SERVICE BULLETIN		Date:	15-May2003	Model: SR8200,SR9200
		Page:	1 / 1	REF.NBR: MZ02-030
		Subject:		
Circulation:	Application:	The problem that the sound of Dolby Digital is		
x for information customer complaint in case of service mandatory 	See Below	Interrupted.

SERVICE BULLETIN		Date:	15-May-2003	Model SR9200/SR8200
		Page:	1/1	REF.NBR:MZ03-010
		Subject:		
Circulation:	Application:	Sound cut a little at the beginning of the track		
x for information customer complaint in case of service mandatory	ALL	 Volume level will decrease when changed Digi Analog input Int.ref: 		ase when changed Digital and

SERVICE BULLETIN		Date:	15-May-2003	Model SR8200,SR9200
		Page:	1/1	REF.NBR:MZ02-040
		Subject:		
Circulation:	Application:	VOL Level and Tune preset memory aren't Back u		
x for information customer complaint in case of service mandatory	Before			
		Int.r	ef:

service bulletin		22-Apr2004	Model: SR8200, SR9200
		1 / 1	REF.NBR: MZ04-034
		Subject:	
Application:	After specific operation, SETUP sometimes returns to initial setting.		
ALL			
	ULLETIN Application:	ULLETIN Page: Application: After s to initi ALL	Page: 1 / 1 ULLETIN Subject: Application: After specific operation to initi

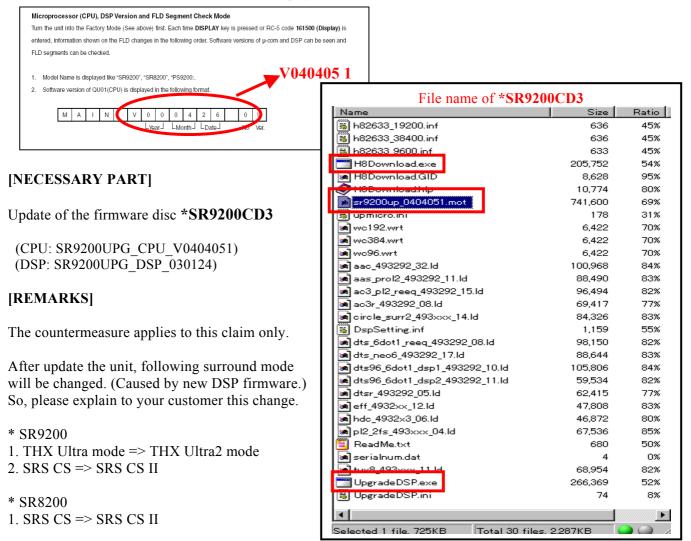
- 1. By SETUP MENU, Set the Speaker level of SURROUND to "+1dB or more". Then, escaping from MENU.
- 2. The Sound level is set to "negative infinity" from "other than negative infinity" by VOL Knob
- 3. Press the POWER switch to turn off and turn on,
- 4. "Clear memory" is displayed and SETUP sometimes returns to initial setting.

1) Update the CPU's software version to [V0404051]

2) Update the DSP's software.

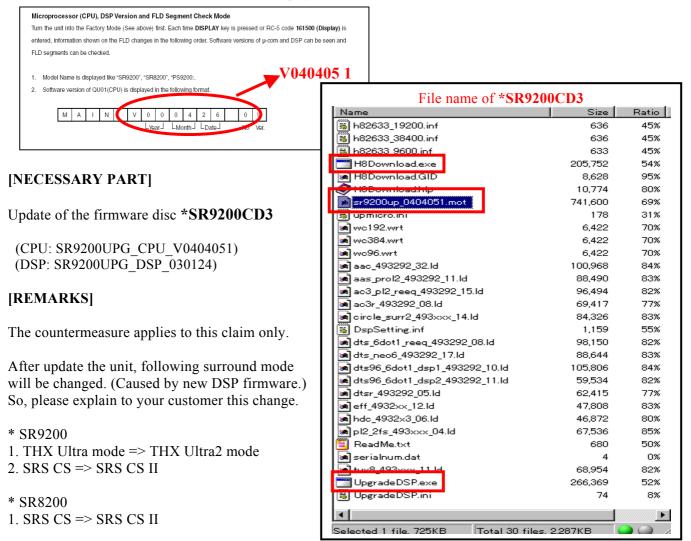
- 1. By SETUP MENU, Set the Speaker level of SURROUND to "+1dB or more". Then, escaping from MENU.
- 2. The Sound level is set to "negative infinity" from "other than negative infinity" by VOL Knob
- 3. Press the POWER switch to turn off and turn on,
- 4. "Clear memory" is displayed and SETUP sometimes returns to initial setting.

1) Update the CPU's software version to [V0404051]

2) Update the DSP's software.
